No. 19. Read the following letter from Major E. LAWFORD, Superintending Engineer Southern Circle, in charge of the Central Office of Public Works; to W. H. BAYLEY, Esq., Acting Secretary to Government, dated 7th June 1858, No. 912.

Memorandum to accompany Mr. FRASER'S Estimate for the repairing and ventilation of Ootacamund Church.

No. 20. ORDER THEREON, No. 1308; dated 7th July 1858.

The following Sketches will illustrate the Plan proposed.

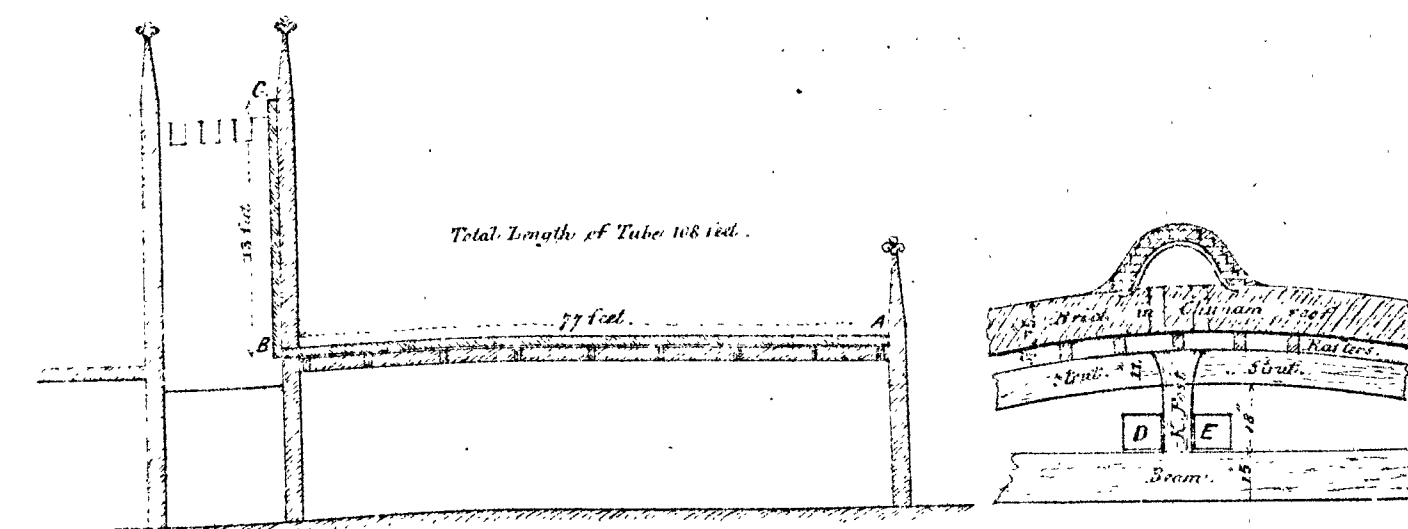
It is proposed to lay along the centre of the roof, an air trunk or tube A. B. C., from the west end of the Church to the Tower; turning up inside, and opening to the atmosphere at the top of the Tower.

Apertures at intervals of a few feet, and alternately on each side of the ridge pole, pierced through the roof, for the purpose of conveying the vitiated air from the body of church into the tube.

It is presumed that the difference in weight between the heated column of air B. C., and surrounding atmosphere, will cause such a draught through the tube, as will thoroughly ventilate the space below—but should this not be the case, any required intensity of draught can be produced, by placing, during the time of Divine Service, a vessel of lighted charcoal in the tube B—upon the top of the tube a cowl should be placed, to prevent, during the high winds, regurgitation of the foul air.

The cross section will show how the sheet iron forming the tube, is proposed to be placed upon the roof: it must be protected by some substance which is a bad conductor of heat, and chunamed over, to throw off the rain—for were the rain allowed to fall upon the iron and evaporate from its surface, its temperature and that of the air inside might be so much lowered as to cause the latter to fall again into the body of the Church and descend to the level of congregation.

The area of the tube is proposed to be $1\frac{1}{2}$ square feet; which is about the result of a calculation made on the supposition, that the greatest number of people in the Church at any one time is 400, and that each person will require 5 cubic feet of fresh air per minute. I do not deem it necessary to go further into this part of the question, as it is one which hardly admits of calculation—for, according to the best authorities, the quantity of fresh air required for each individual, ranges from 3 to 10 cubic feet per minute—besides by having a fire and a damper at point B. the draught can be regulated to suit any required degree of ventilation.

Instead of constructing one sheet iron tube upon the roof,—two smaller tubes of tin or copper, one on each side of the ridge post, might be laid upon the beams under the roof as shown at letters D. E., on the cross section: they—after passing through the wall at the back of the Gable—could be connected with a single up-cast shaft of sheet iron in the Tower, as already proposed—this would avoid any interference whatever with the roof, and as the tubes could be made of timber would be a cheaper plan, than that already described:—it is however objected to, as supposed the tubes would disfigure the appearance of the Church.
